- Via: email to Lynne Bermudez <u>lbermudez@topsfield-ma.gov</u> email to Matthew Cote <u>lbermudez@topsfield-ma.gov</u>
- Re: Emerson Homes, LP (Chapter 40B Comprehensive Permit Application) 10 High Street, Topsfield MA Update to peer review comments received.

On behalf of Emerson Homes, LP for the above referenced project, DeVellis Zrein Inc. (DZI) is pleased to respond to the Civil Engineering and Landscape Architectural review comments received in the **April 14, 2023** Beals + Thomas peer review letter.

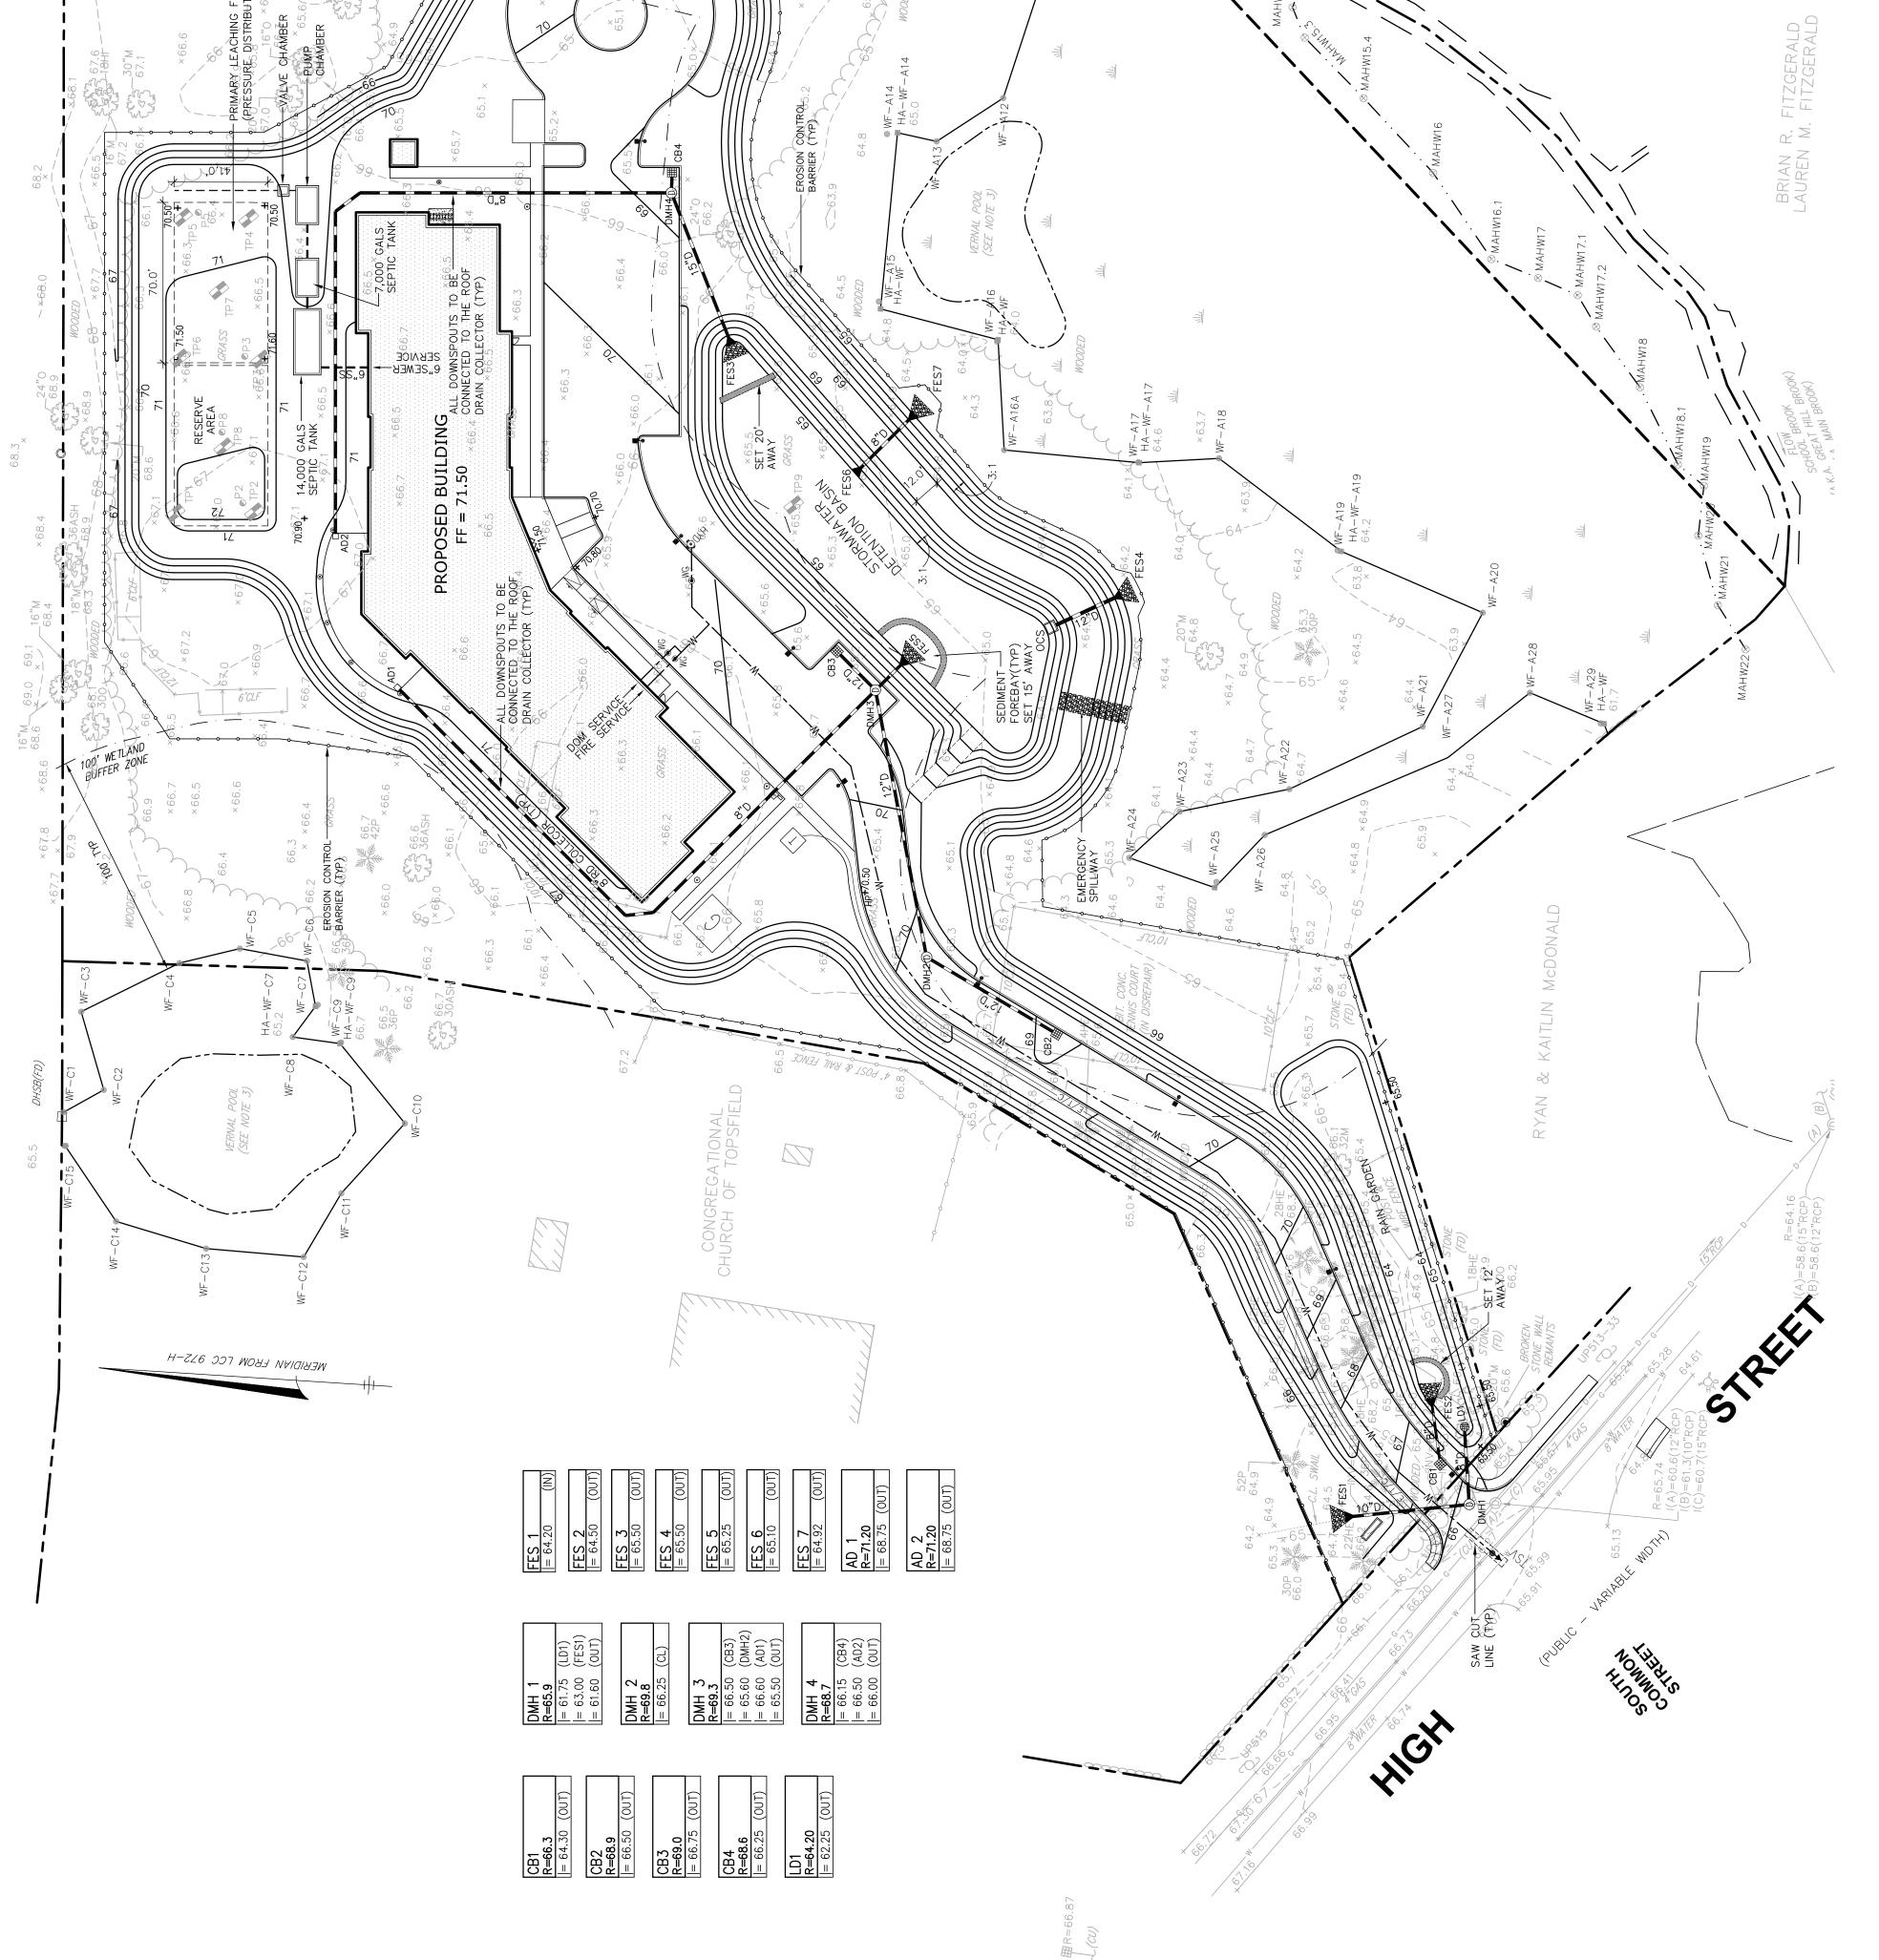
<u>B+T COMMENT</u>: B+T takes no exception to the waiver request and concurs that the Applicant shall follow the requirements of the Project SWPPP. However, it appears a small portion of the access driveway will drain to High Street, contrary to the requirements of 384-4(K)(8). We request that the Applicant clarify the intent of stormwater management design west of proposed catch basin CB1.

DZI RESPONSE: CB1 has adjusted towards the road to intercept the drainage runoff prior to entering the roadway. Revised Plan Sheet C-2 is attached showing the change.
